PCN-20201004 TE0876-02 SPI Flash Change

Company	Trenz Electronic GmbH
PCN Number	PCN-20201004
Title	TE0876-02 SPI Flash Change
Subject	BOM change
Issue Date	2020-10-06

This change affects all Trenz Electronic TE08760 modules of revision 02.

Locate Flash (U12) at top side of PCB:

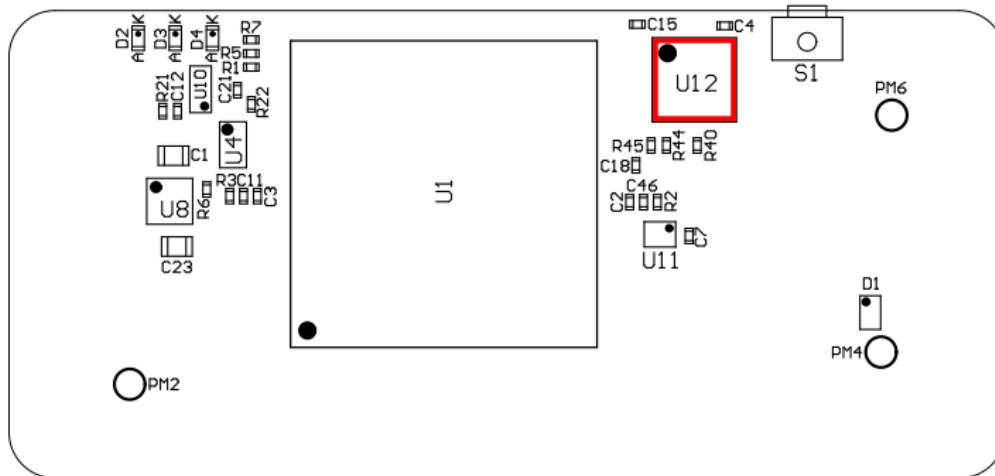
#1 Change SPI Flash from N25Q064A13ESE40F to IS25LP064D-JBLE

Reason: Old flash is obsolete.

Impact: JEDEC ID changes from BA17h to 6017h and manufacturer ID from 20h to 9Dh.
